Marine Management Organisation

MMO Reference: DCO/2019/00008
Planning Inspectorate Reference: EN010115
Identification Number: 20049306

Planning Act 2008, Five Estuaries Offshore Wind Farm Ltd, Proposed Five Estuaries Offshore Wind Farm Order

This document comprises the Marine Management Organisation's ("MMO") initial comments in respect of the above Development Consent Order application ("DCO Application") in the form of a relevant representation.

Figure 2. Diagram of a piled foundation Wind Turbine Generator (Figure 1.3 of ES Part 2 Chapter 1 Offshore Project Description).

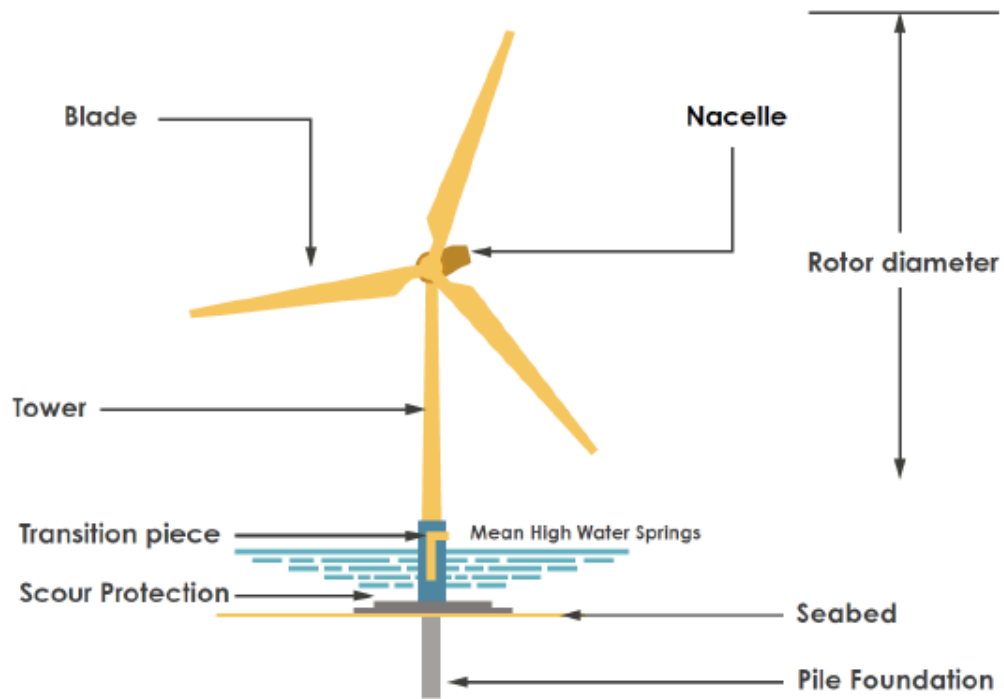
- 4.2.2 The project description is as clearly presented as could be reasonably expected at this stage. However, considering the proximity of the VE project to the Galloper OWF (and the Applicant stated benefit of using existing datasets when extending operational OWFs), the MMO queries the inclusion of gravity base jacket foundations as the engineering solution in the assessment (as worst-case scenario) rather than the pile foundations achieved at Galloper (and presented in Figure 1.3 of Volume 6, Part 2, Chapter 1 of the ES – also see Annex 1, Figure 2 below).

Figure 3. Location of Projects considered within the benthic and intertidal ecology cumulative effect assessment (Figure 5.8 in ES Part 2 Chapter 2 Marine Geology, Oceanography and Physical Processes).

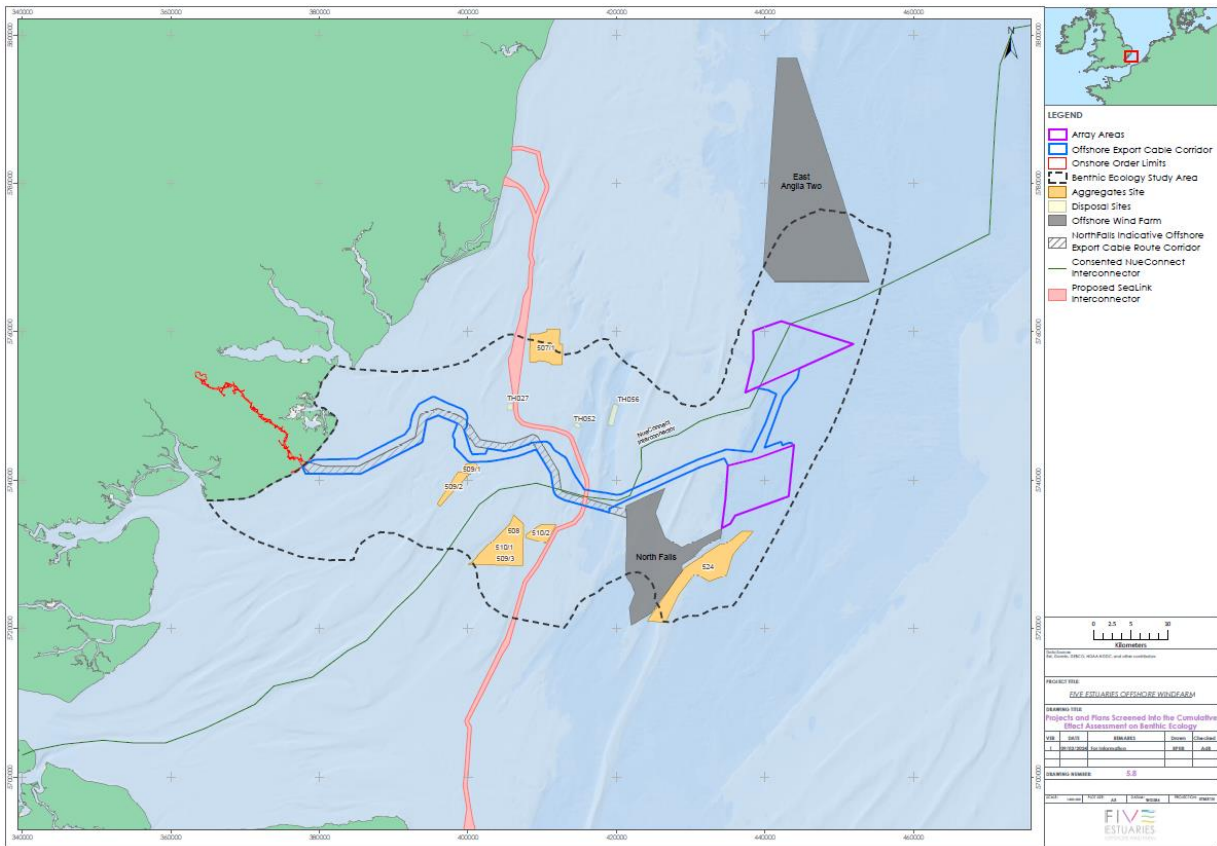
- 4.2.9 The cumulative impact assessment for benthic ecology receptors includes a long list of projects to be considered, alongside the status (at the time of reporting) of each development, and an appropriate study area has been used in the assessment as shown in Figure 5.8 of the Benthic and Intertidal Ecology chapter (also see Annex 1, Figure 3 below).
